Name:	Prod No:	Rev:
USB on Developerboard LX	xxx	R1_3
CIRCUIT DIAGRAM	Date:	Des:
AXIS COMMUNICATIONS AB, SWEDEN	May 22, 2002	MM
	Sheet	Appr:
	1 of 1

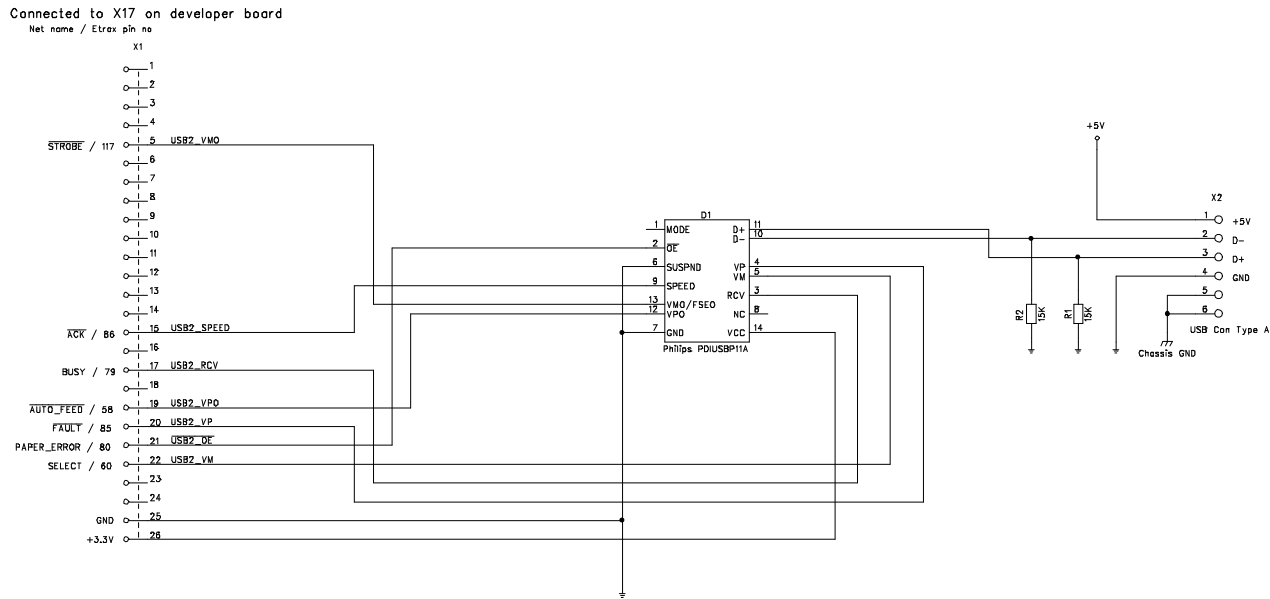
Some hardware related modifications on the Developerboard LX might be necessary when connecting a USB port to X17. R113, R114, R112, R115, R116 are all 4k7 ohm and this is too much. Replace these with 0 ohm resistors instead. The pull up resistors R106 and R107 shall be replaced with 4k7 ohm.
